**REMARKS**

PATENT APPLICATION  
Docket No. 99-C-179D1

**IN THE DRAWINGS:**

FIG. 2B

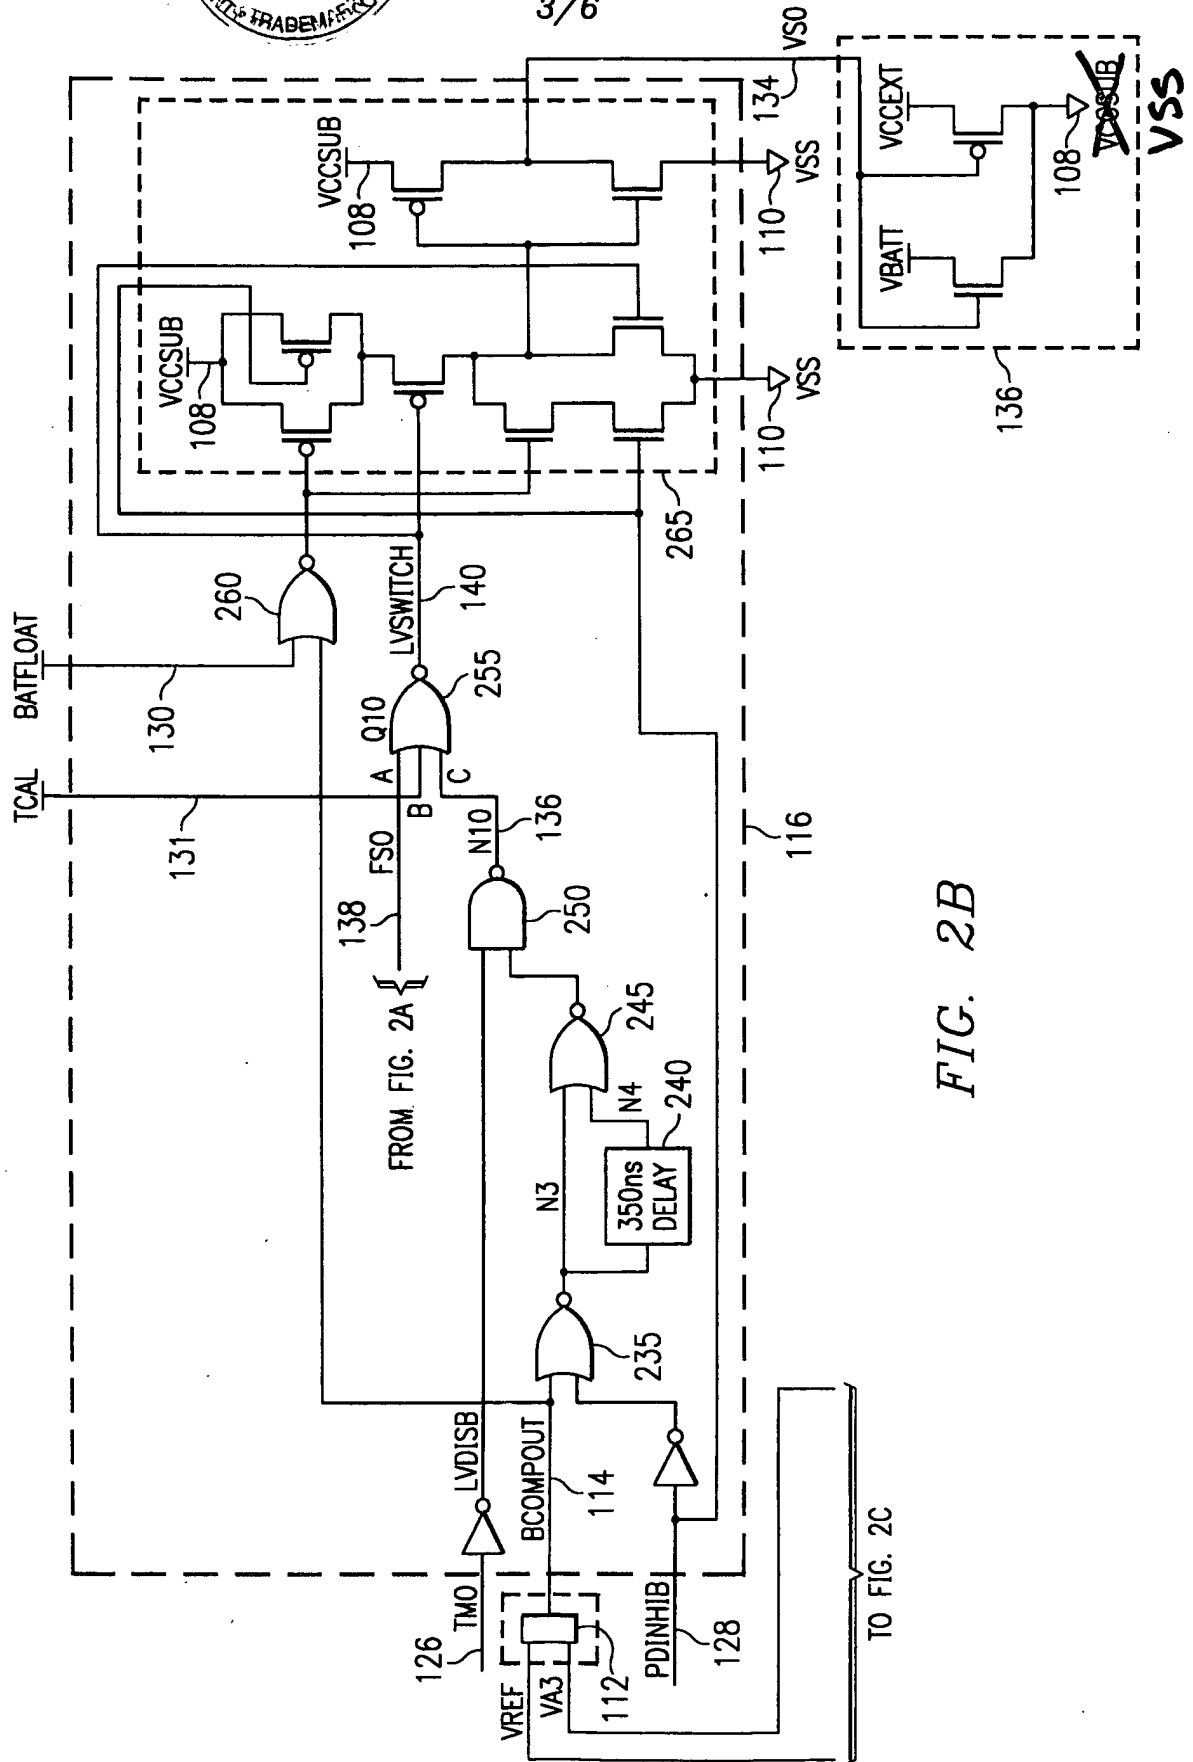
In the lower right-hand corner of Figure 2B, please change the ground reference from "VCCSUB" to "VSS" as indicated in red in the attached proposed drawing correction.
